U.S. Department
of Transportation
**Federal Aviation
Administration**

Subject: **ACTION:** Documentation of Equivalent Level of Safety
(ELOS) Finding No. ACE-01-02, Sino Swearingen Aircraft
Company Model SJ30-2, 14CFR 23.1305, Digital Display of N2
and Fuel Flow.

Date: April 18, 2001

Figure 1 – Multifunction Flight Display Primary Engine Instrument Stack

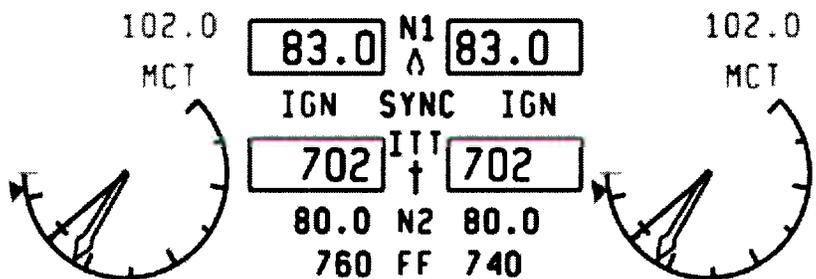
Digital N₂ and Fuel Flow are presented in a vertical stack of primary engine instruments for both the left and right engine. This is shown in the figure below. This stack is displayed on the top of the multifunction flight display (MFD). The MFD is located slightly to the right of the pilot centerline view and is adjacent to the primary flight display. Due to the nature of electronic displays no pointer vibration will occur. Lighting and instrument panel vibration will have no appreciable effect on any of the engine displays.

Compensating factors for N_2 include the fact that the design of the engine is such that the limiting N_2 can not be reached before exceeding the N_1 or ITT limits as stated in the correspondence from Williams International. In addition, the critical parameters (N_1 , ITT), relative to the N_2 limit issue have both analog and digital displays as shown in the figure 1.

The design of the SJ30-2 primary engine instrument stack (Figure 1) shows that left and right engine digital parameters are adjacent to each other allowing for extreme ease in comparison including Fuel Flow and N_2 .

N_2 compensating factors include the fact that the design of the engine is such that the limiting N_2 can not be reached before exceeding the N_1 or ITT limits as stated in the correspondence from Williams International. The critical parameters (N_1 , ITT) have both analog and digital displays as shown in the Figure 1.

AC 23.1311-1A, section 8.5.6, items 8.5.6.1 through 8.5.6.5, and section 8.5.7 define the specific factors that should be considered when seeking an ELOS for use of digital only displays. These items have been addressed in the applicants position. The FAA agrees with the proposed ELOS.

The FAA concurs with the Sino Swearingen position and finds an Equivalent Level of Safety to 14 CFR part 23.1305 (c)(2), (c)(5), and 23.1549, (a) through (c) as required by 14 CFR Part 21.21(b) may be granted for the use of direct reading, digital only displays for engine high-pressure turbine speed (N₂) and fuel flow for the SJ30-2 airplane.
